Public Information Centre #2

Ojibway Parkway Wildlife Crossing
Municipal Class Environmental Assessment (Phase 1 to 4)
Windsor, Ontario

Public Information Centre #2 Summary Report

Table 4-1: Summary of PIC #1 Comments and Study Team's Responses

Preliminary Preferred Design Concept

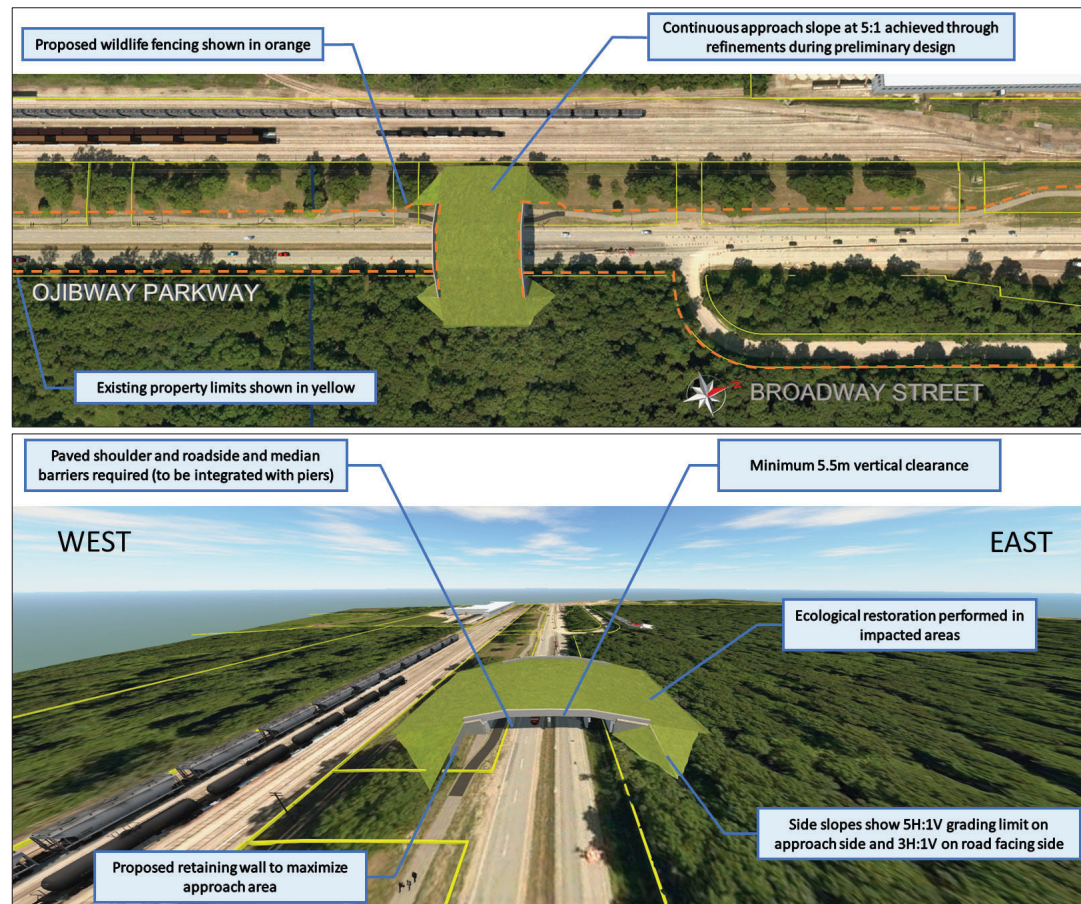
Comment#	Method of Submission	Would you like to be added to the Study Contact List?	Do you have any comments on the evaluation of alternative design concepts process?	What do you think about the Preferred Design Wildlife Overpass (4 Span Bridge)?	Do you have any other comments?	How was your experience with using the Virtual Consultation Platform for this project?2
1	Online Comment Form	Yes	Hi: Mitigation to reduce road mortality must be the top priority for wildlife. It appears most of the expenses associated with the project are associated with enhancing connectivity. In my opinion the former money is very well spent and will yield substantial benefits (small mammals, reptiles in particular). On the other had, I believe the money spent on connectivity is very inefficient. Worse, I fear photos of this design will make it into Conservation Biology textbooks (I teach this topic at the University of Windsor) as a failed and expensive measure.	Because the overpass will not truly connect forest patches, it is at best providing pseudo-connectivity. Dr. Lenore Fahrig (Carleton U) - the world's top female ecologist and road specialist - gave a talk to a Latin American Biodiversity conference in December 2020 in which she stressed that mortality reduction associated with roads dramatically exceeds in importance habitat connectivity. The amount of money devoted to the overpass (\$10 million?) would be far better spent on additional land acquisition or landscape enhancement of existing, nearby forest tracts. If lack of gene flow or demographic rescue is deemed important, then individuals could be transferred to one forest tract from another source:sink population model), as needed. I would urge council to maximize the ecological benefits if \$13.5 million is going to be spent.	Absent a complete overpass system including the train tracks to the west, both ecological efficiency and cost-efficiency would be best served by not building the road overpass. I would urge the team deciding on the final strategy consult with Dr Fahrig before making a final decision.	Fine.

2	Online Comment Form	Yes	I always dislike the process when the end result is already determined by the city administration. Then they design the process so all comments are precised by the administration to be the result the city wants not the choice of the wildlife experts.	To go along with my previous comments it is the second best solution. The Preferred Design Wildlife Overpass solution should also span the tracks, do it all at once because costs only go up the longer it is delayed	I hope the city administration builds the correct Wildlife Crossing that includes the railway tracks. The city should quit the stalling tactics; just get the cross the Wildlife deserve built.	I Thought it was a exceptional experience.
3	Online Comment Form	Yes	I think this design process is economical for the time being. I agree with this route based on the cost of the overpass. As long as animals are being saved for now it will do.	I would prefer this design over the alternative because it would be the best for the wildlife in the area but the issue of cost is important and unless someone is willing to donate the money. I think building the alternative and leaving room for another phase in the future is the best option.	No	It was okay. I thought the rendering was cute and interesting.
